Section A-A

REV	NOTE	DATE	DRAWN
H	Issued for Planning	25/11/2024	TS / HC

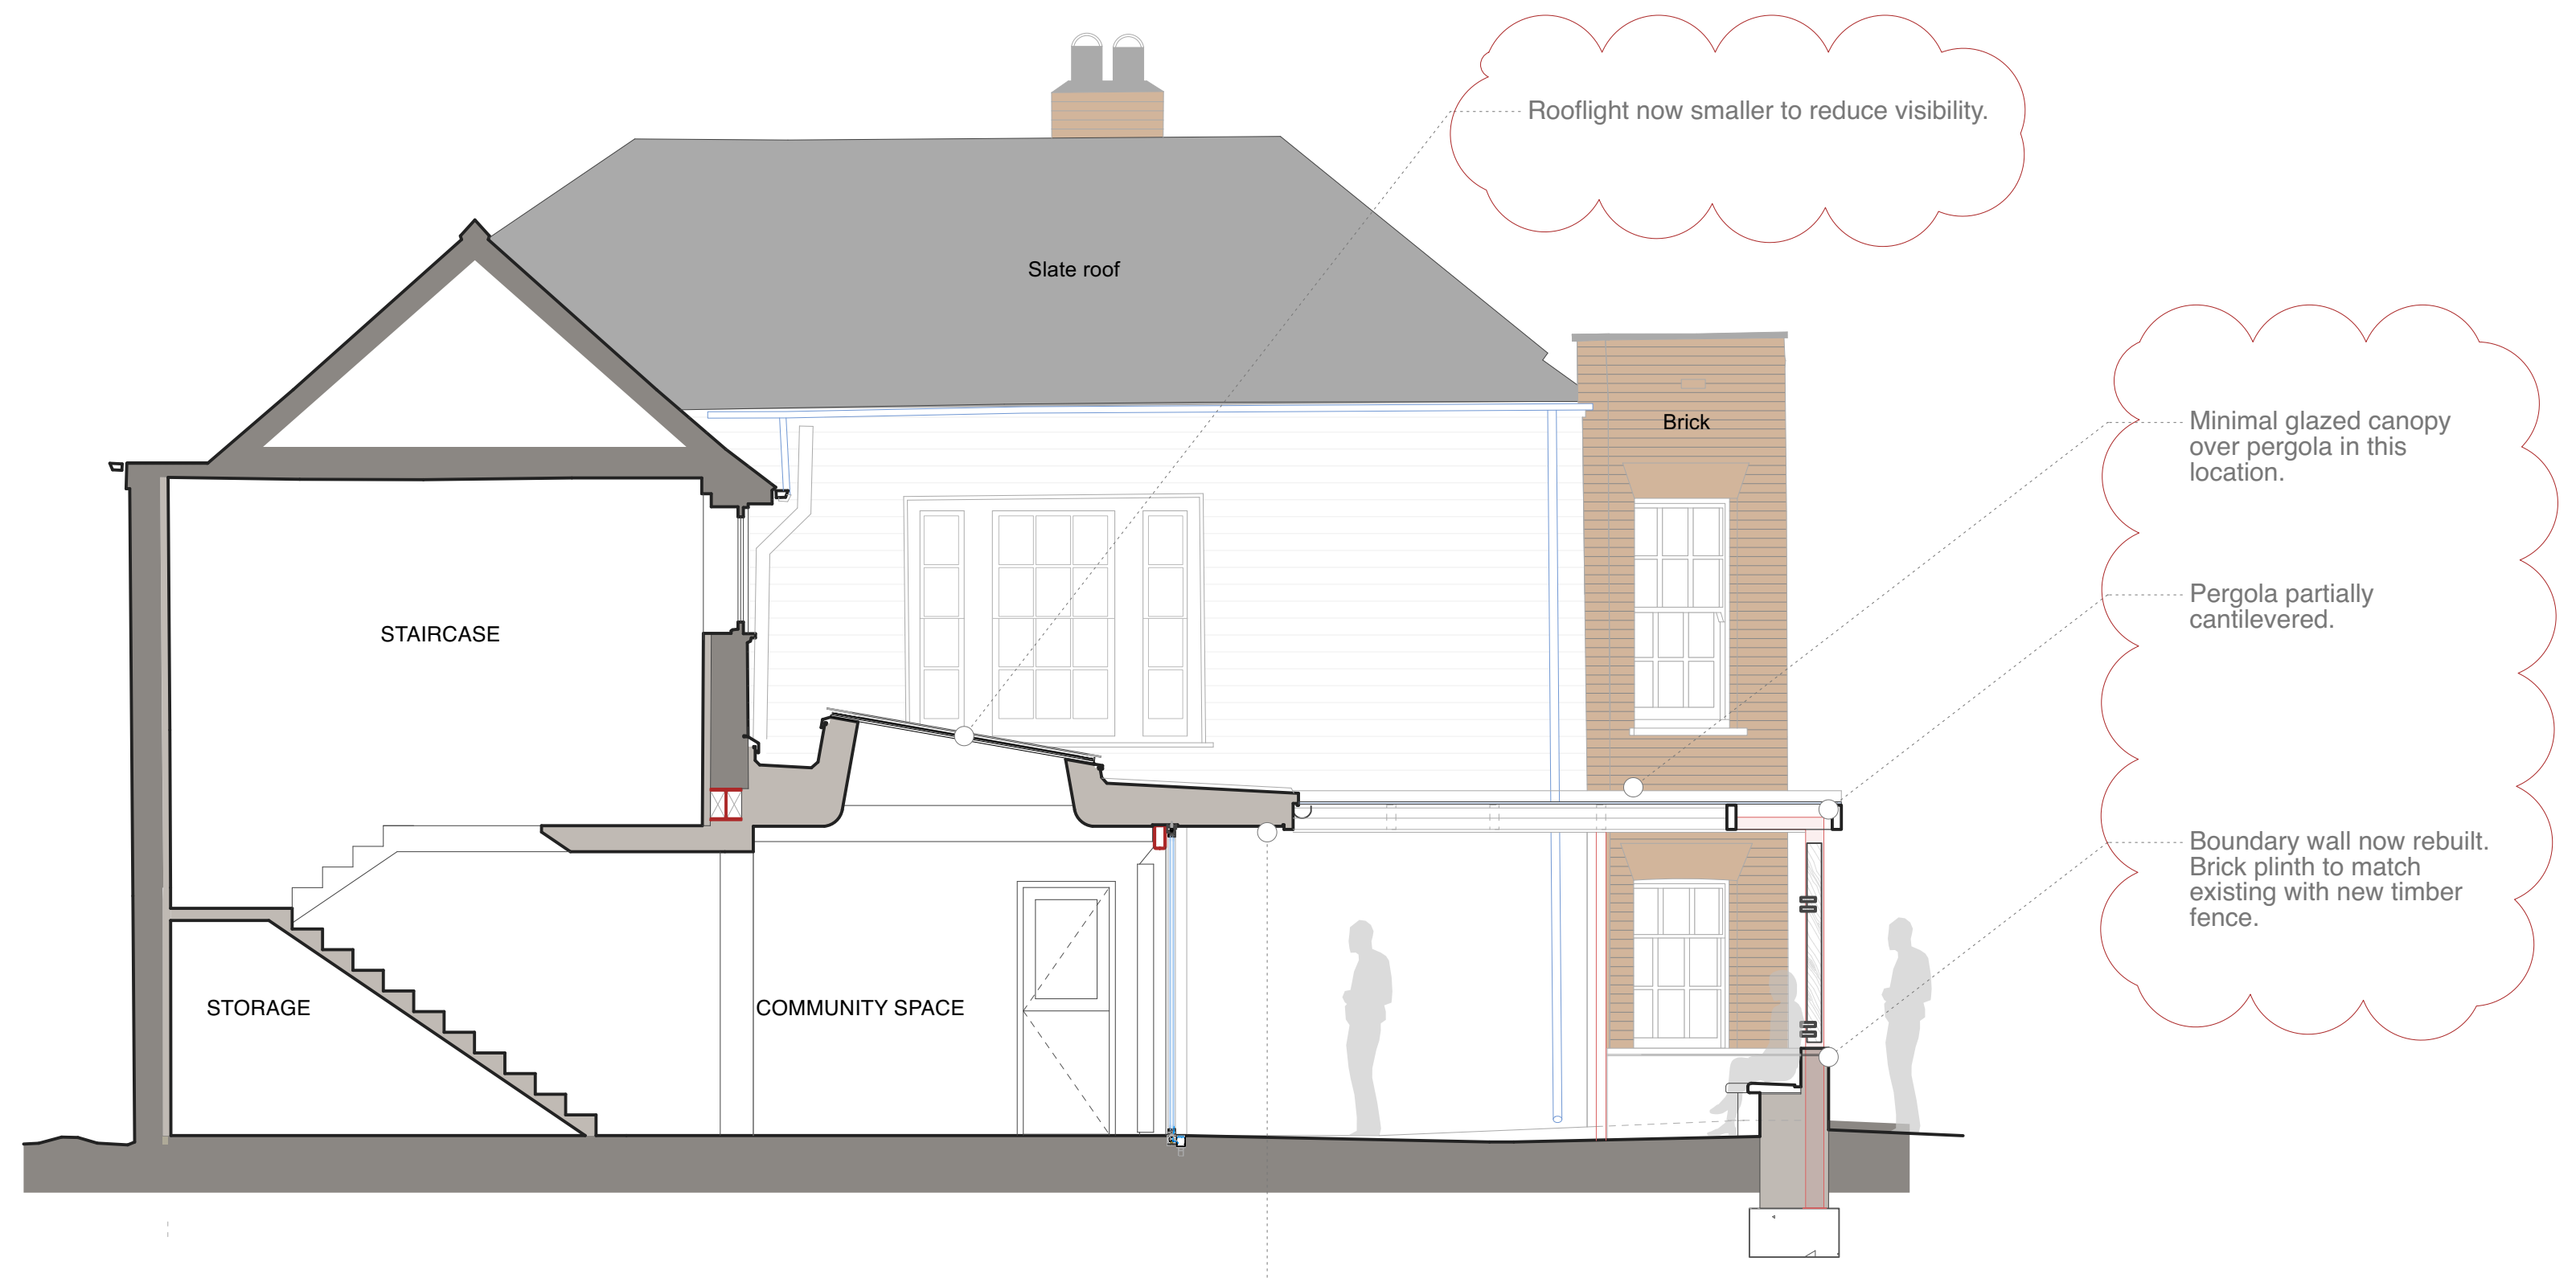
New veranda now cantilevered and supported at ends rather than new posts installed.
 To allow for outward-opening door swing.
